**Design Memorandum No. 17-03**  
**Technical Advisory**

**SUBJECT:** Mechanically Stabilized Earth (MSE) Walls

**REVISES:** *Indiana Design Manual* Sections 402-6.02(02), 409-2.04(02), 409-3.03,  
Figure 409-2G, and Figure 410-5(0)C (new)

**Figure 409-2G  
(Sheet 1 of 2)**

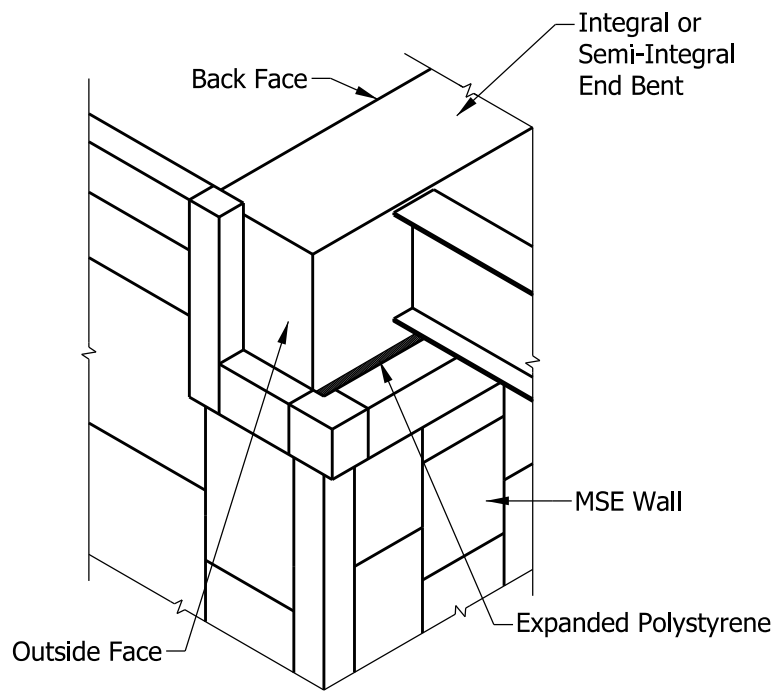
IDM 409-2.04(02) Integral End Bent – Design Requirements, 409-3.03 Semi-Integral End Bent, and Figure 409-2G Figure 409-2G illustrates the minimum distance from the edge of the pile sleeve to the back of the MSE wall panel and preferred MSE wall configurations at an end bent.

MSE Wall at an End Bent. When an end bent is placed behind an MSE wall, expanded polystyrene should be shown for gap between the front face of the end bent and the back of the MSE wall. Do not show Styrofoam or extruded polystyrene. See Figure 409-2G, End Bent Placed behind MSE Wall for additional details.

**NOTE:**

Coarse aggregate and 6" end-bent drain pipe are not required to be specified separately for an end bent placed behind an MSE Wall.

- d. Where utilizing an MSE retaining wall at an end bent, a minimum distance of 3 ft. is required between the back of the wall panel and the edge of the pile sleeve or the pile (where sleeves are not required). For determining preliminary structure span length, a 24-in pile sleeve should be assumed. The need for pile sleeves will be determined by the Office of Geotechnical Services. *LRFD* 11.10.11 provides additional information regarding the placement of obstructions in the reinforced soil zone.

Figure 409-2G  
(Sheet 2 of 2)

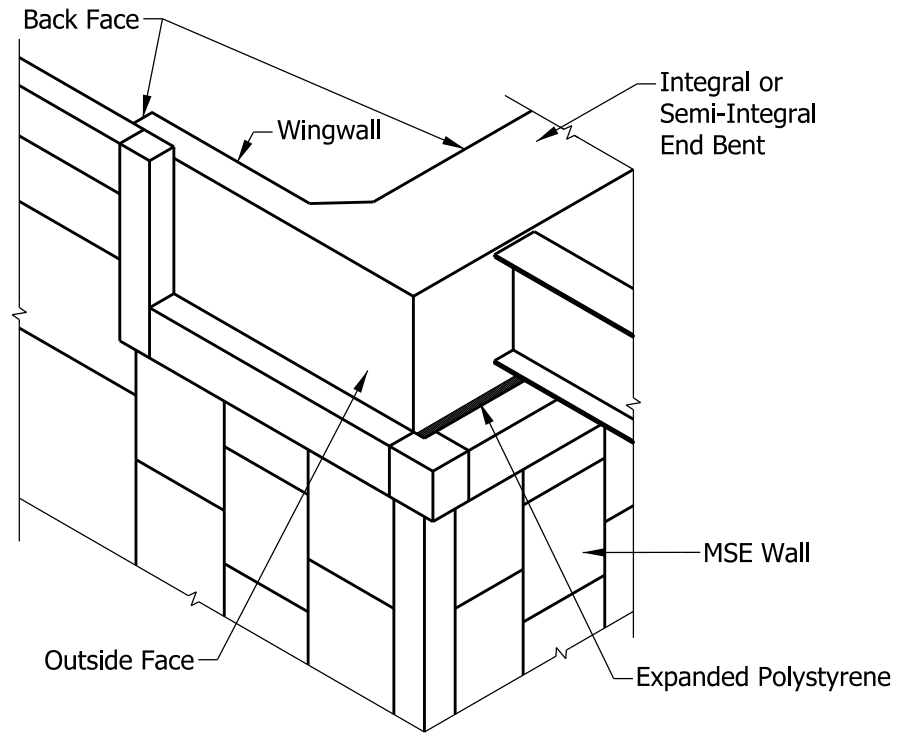
**NOTE:**

Where an MSE is placed parallel to the bridge approach roadway, it should be placed adjacent the outside face of the end bent or wingwall, but not cast against it. Sufficient clearance is needed to accommodate the thermal movement of the end bent. The MSE wall should not be placed abutting the back face of the end bent or wingwall.

Figure 410-5(0)C

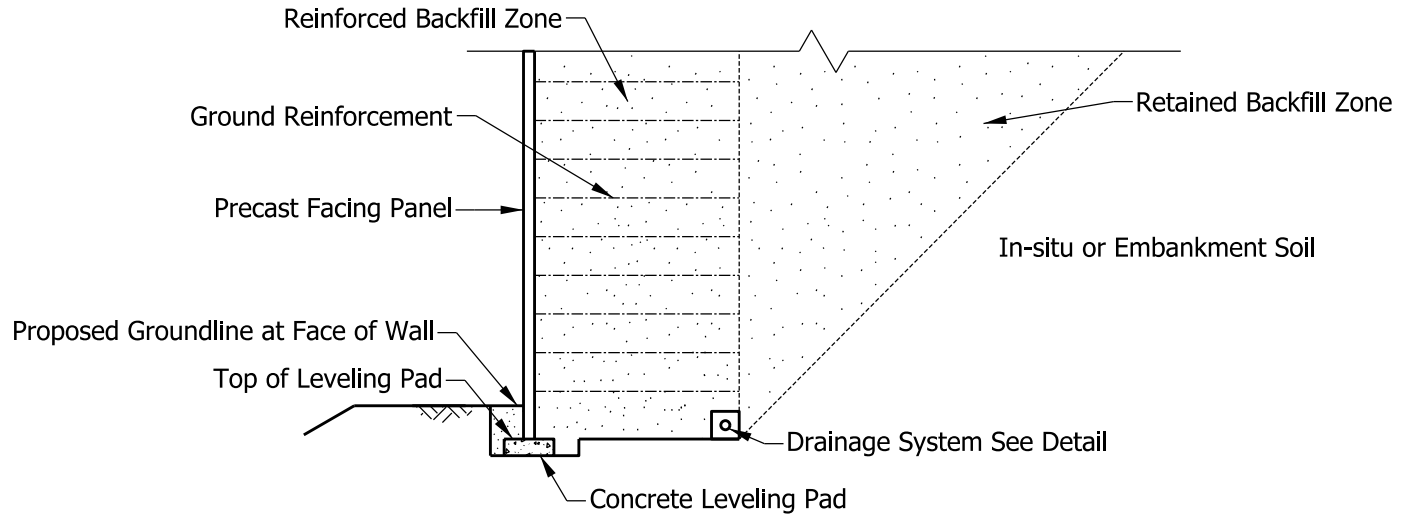
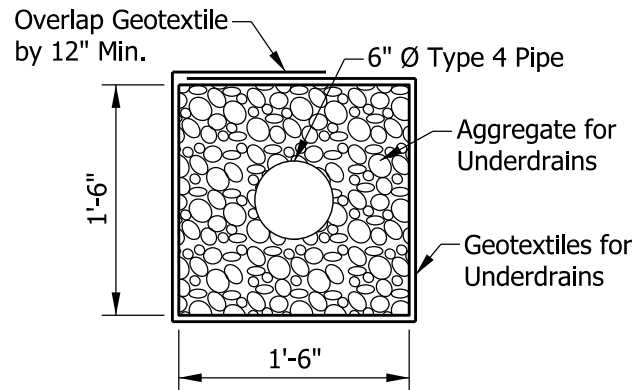
IDM 410-5.01(07), Figure 410-5(0)C (New), Information to be Shown on Plans

- Drainage systems are required for all MSE walls. Figure 410-5(0)C illustrates a typical MSE wall cross sections and provides the drainage details to be included on plans.
- A plan view showing all obstructions and their offset from the back of the MSE wall is required on the MSE Wall Details sheet. Obstructions include but are not limited to, piles, pile sleeves, catch basins, signal or sign foundation, guardrail posts, and culverts. Where an obstruction projects through the MSE wall panel, the obstruction should also be shown in an isolated section and elevation view.
- Modifications to the wall design to avoid obstructions must be shown in the MSE Wall working drawings. Design options for obstructions within the reinforced zone are described in the *AASHTO LRFD Bridge Design Specifications*, section 11.10.10.4.

**Drainage.** Details for drainage of the surface-water infiltration and reinforced-soil backfill should be included for all MSE walls. Figure 410-5(0)C shows the standard drainage details. It is the designer's responsibility to determine the elevation of the drainage pipe such that it will drain and outlet adequately.
